Appl. No. 10/604,855
Amdt. dated December 13, 2004
Reply to Office action of October 21, 2004

REMARKS/ARGUMENTS

Fig. 3

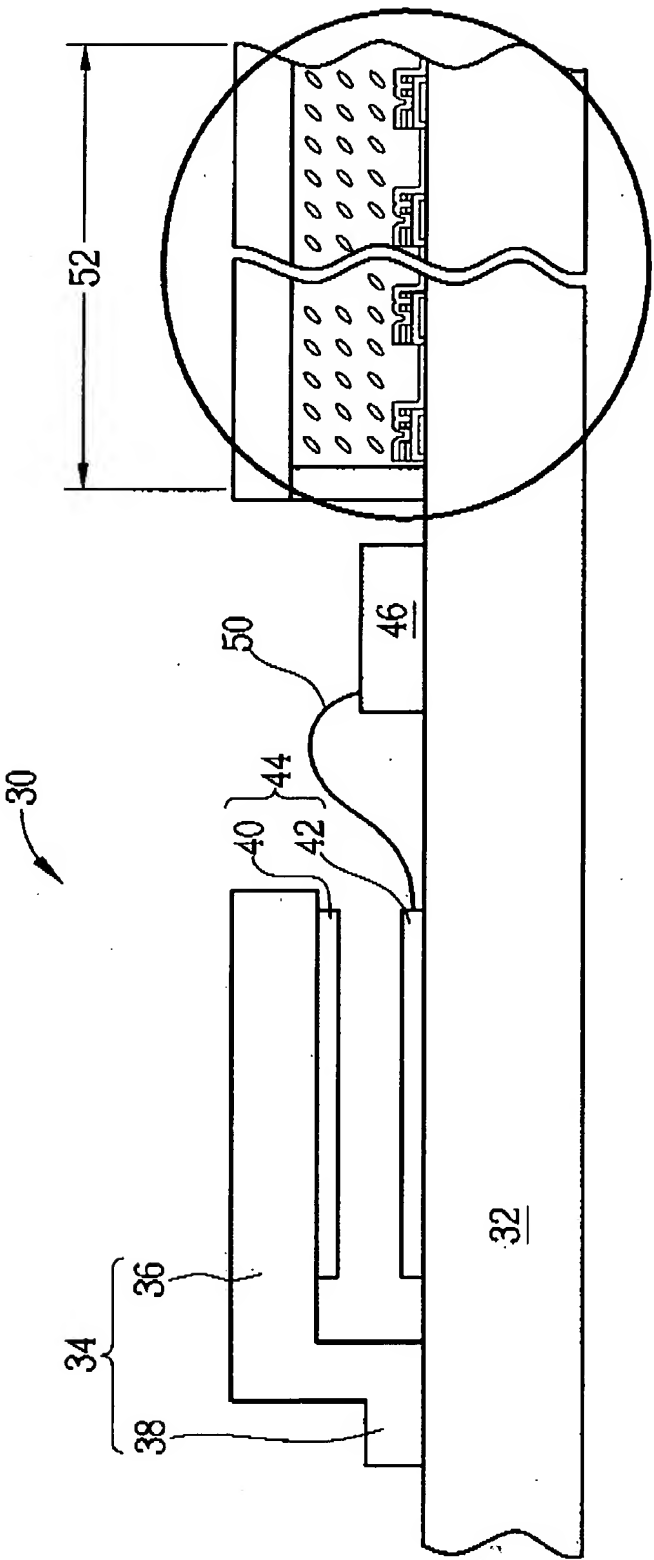
Fig.3 has been redrawn to clearly illustrate the TFT display area 52, as shown in the encircled area of the attached "Annotated drawing sheet". No
10 new matter is introduced by the above amendments, since it is in accordance with the originally disclosed TFT display area. Consideration of the proposed amendment to the drawings is politely requested.

The attachment (2 pages) includes a "Replacement Sheet" of Fig.3 and an "Annotated Drawing Sheet" showing changes.
